Marine
Management
Organisation

MMO Reference: DCO/2022/00007
Planning Inspectorate Reference: EN010125
Identification Number: 20050160

Planning Act 2008, RWE Renewables UK Dogger Bank South (West) Ltd and RWE Renewables UK Dogger Bank South (East) Ltd Proposed Dogger Bank South Offshore Wind Farms Order

Deadline 8 Submission

Figure 1: UWN modelling in relation to the herring spawning ground off Flamborough Head. Showing unmitigated and mitigated noise contours (ERM 2024).

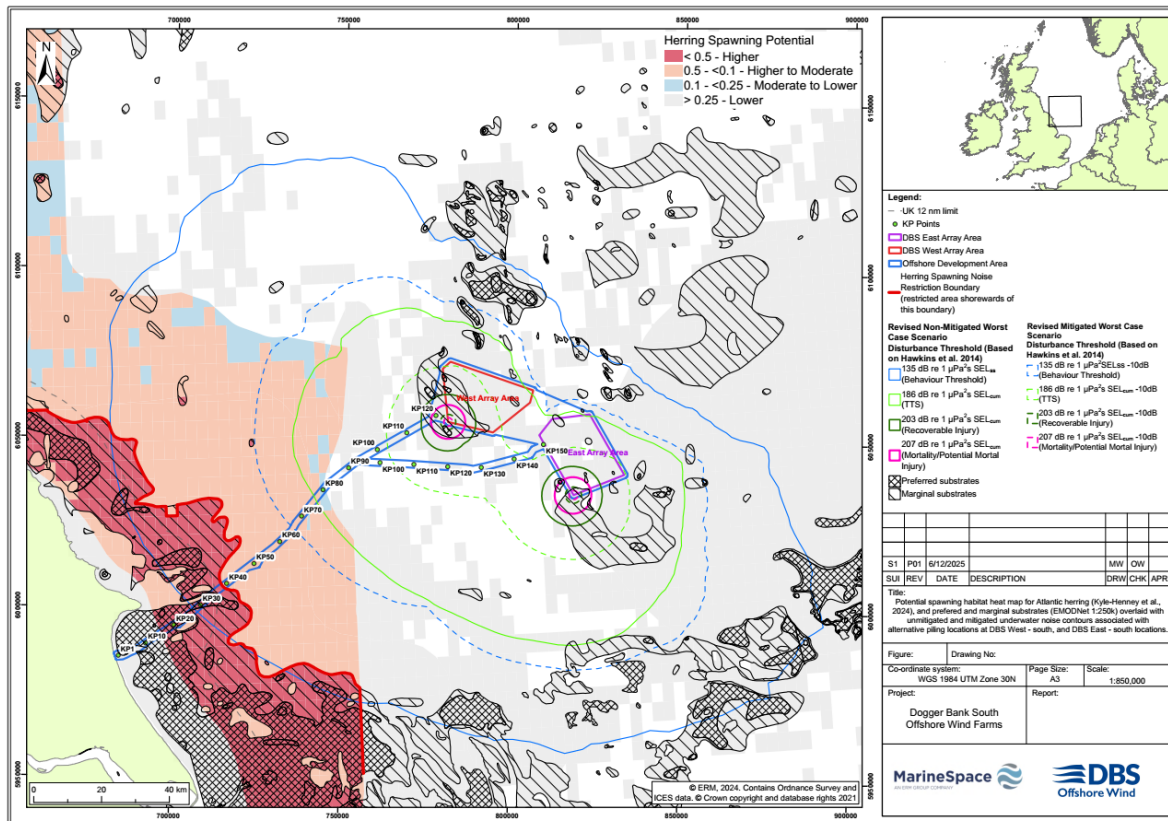
- 4.8.3 In summary, herring will be vulnerable to TTS in a small portion of the spawning ground, and vulnerable to behavioural responses across a large area of the spawning ground (see Figure 1). Given that herring are substrate-specific spawners we have concerns that UWN from piling may cause behavioural disturbance which may cause fish to avoid their spawning ground due to noise disturbance. Given their reliance on specific seabed substrates, if herring react to the noise disturbance caused by piling by moving away from the spawning ground, then there is potential for spawning failure to occur.

- 4.8.4 There is also a further risk, that piling noise may disturb herring migrating through the North Sea from north to south to reach their spawning grounds. Within Figure 1, the Applicant has also presented modelled noise contours based on the use noise abatement systems (NAS) such as hammer cushions and bubble curtains. However, the Applicants have not made a commitment to using NAS, and thus the risk to herring at the spawning ground remains and the MMO maintains that a restriction on piling should be conditioned on the DML from 1 August to 31 October, inclusive).

Figure 2. UWN modelling in relation to sandeel habitat and spawning ground and UWN modelling (RWE, November 2024).

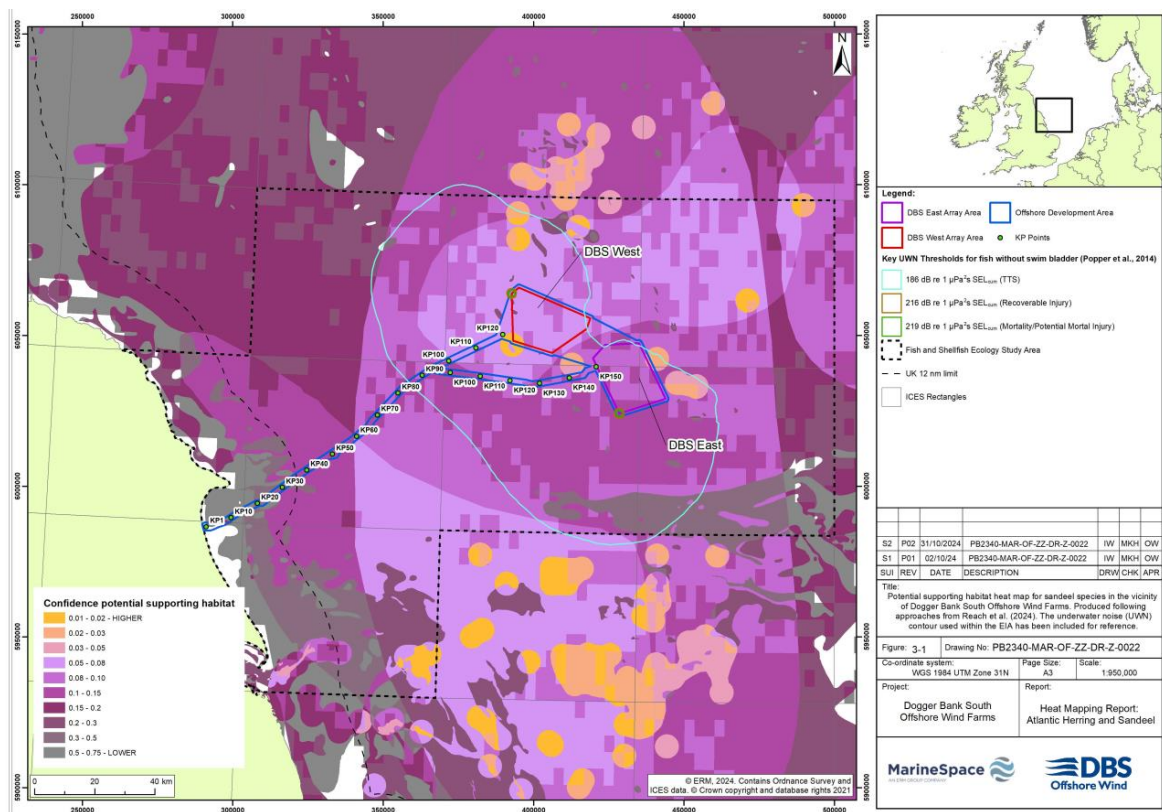
4.8.6 The UWN modelling presented in the Applicant's Heat Mapping Report: Atlantic Herring and Sandeel (RWE Nov 2024) shows the noise contours for the range of effect for mortality and potential mortal injury, recoverable injury and TTS in sandeel (see Figure 2). As can be seen from Figure 2, the ranges of effect for mortality and potential mortal injury, recoverable injury are small in the context of the wider available habitat. However, it should be recognised that the UWN modelling represents one modelled pile in each array area, whereas in reality, these impact ranges will occur at all sites where piling of foundations takes place, across each array. The heat map of sandeel habitat suitability in Figure 2 indicates that pockets of the array areas have 'very high' levels of confidence as sandeel habitat (denoted by orange colours), with the wider area being 'high' and 'medium' confidence as sandeel habitat. The impact range for TTS encompasses a much wider area of the sandeel habitat, so extends across the 'very high', 'high', 'medium' and 'low' confidence areas.

4.8.7 Given that much of the DBS array areas is considered to be an important sandeel habitat, it cannot be discounted that we can expect to see mortality and potential mortal injury and recoverable injury across the array areas at sites where piling is taking place, hence we can expect the impacts to be localised. The wider reaching effects of TTS occurring across the site are also of concern, and whilst not discounting the vulnerability of sandeel to UWN (and habitat) disturbance during construction of the windfarms, especially during their hibernation and spawning periods, we do not have major concerns that significant impacts to sandeel will occur at a population level as a result of UWN from piling. This is, in part, due to the wider availability of suitable sandeel habitat, and takes into the soft-start procedures on commencement of piling that will allow sandeel to move away from the sound disturbance and avoid auditory injury.

4.8.8 However, the MMO welcomes that the Applicants will be undertaking post-construction monitoring of sandeel habitat suitability, to determine whether the seabed within the array areas remains suitable for recolonisation. It should be recognised that monitoring of sandeel habitat suitability is just that, i.e. it only considers whether sediments are suitable for sandeel to inhabit but does not actually gather any data on presence/absence or abundance of sandeel.
